**REPORT NUMBER: 63/22**

DEVELOPMENT NO.:	21036450
APPLICANT:	Brett Fleetwood
ADDRESS:	38 TARLTON ST SOMERTON PARK SA 5044
NATURE OF DEVELOPMENT:	Carport attached to side of dwelling, shed in rear yard, and verandahs
ZONING INFORMATION:	Zones:
	General Neighbourhood
	Overlays:
	Airport Building Heights (Regulated)
	Affordable Housing
	Building Near Airfields
	Hazards (Flooding)
	Hazards (Flooding - General)
	Prescribed Wells Area
	Regulated and Significant Tree
	Stormwater Management
	Urban Tree Canopy
LODGEMENT DATE:	16 Nov 2021
RELEVANT AUTHORITY:	Assessment panel/Assessment manager at City of Holdfast Bay
PLANNING & DESIGN CODE VERSION:	4 November 2021
CATEGORY OF DEVELOPMENT:	Code Assessed - Performance Assessed
NOTIFICATION:	Yes
RECOMMENDING OFFICER:	Dean Spasic
	Development Officer - Planning
	-

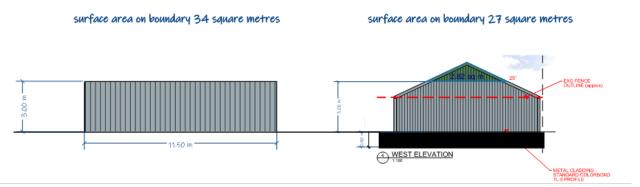
When considering the boundary wall height, in this case, the 4.1 metre high gable end, it is acknowledged that this exceeds the height limit by 1.1 metres. When determining the impact of a design element that does not satisfy the Design Code, it is important to have regarding to the following:

Firstly, the illustration below demonstrates the extent of boundary walling allowable by the Design Code against the extent of walling proposed by the shed. In summary:

- The proposed shed has a surface area that is 7 square metres less than a 3m high x 11.5m long wall; and
- The proposed gable end is 1.1 metres higher than the maximum boundary height:

Secondly, when considering the visual impact on the western adjacent property (which has a bedroom and living room adjacent to the proposed shed), it is considered that the visual impact of the proposed boundary development would be similar to that achievable via the Design Code parameters, as per the above illustration suggests.

In summary, the subject site is a large parcel of land, with a large rear yard. There is sufficient means available for the applicant to make amendments by way of a rear boundary setback or hipping the roof so as to avoid the gable end impact on the boundary. The proposed shed will contribute to overshadowing, to which the extent can be avoided by way of some minor amendments.
